### **Dam Safety Inspection Report**

INVENTORY NO.: TX03755

DAM: LAKE CHARMAINE DAM

OWNER: CITY OF IVANHOE

**Photo #16** – View of cracking occurring in the concrete slab along the entrance to the spillway looking south.

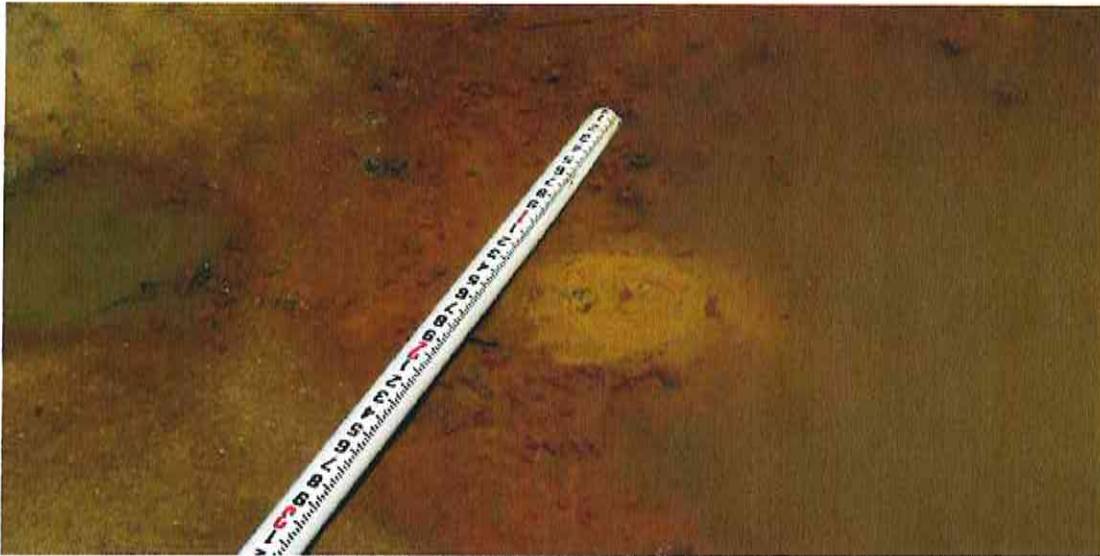
- The spillway is located at the left end of the embankment and consists of a 160-ft wide weir wall, debris grates, bridge and concrete downslope and stilling basin. The overall structure and components were found in fair condition (See Photos 13-19).
- Some cracking and spalling was evident around the concrete bridge and slopes next to the spillway/bridge (this appeared about the same as noted during the last inspection).
- Sediment buildup (which was partially cleared out during the grouting project) was evident at the right end of the stilling basin. This is the same location where boils and sediment buildup were noted in previous inspections.

- c) Heavy vegetation growing around the stilling basin area should be removed.
  - d) Repair spalling, and seal minor cracks throughout the concrete slabs, particularly around the bridge and service spillway area.
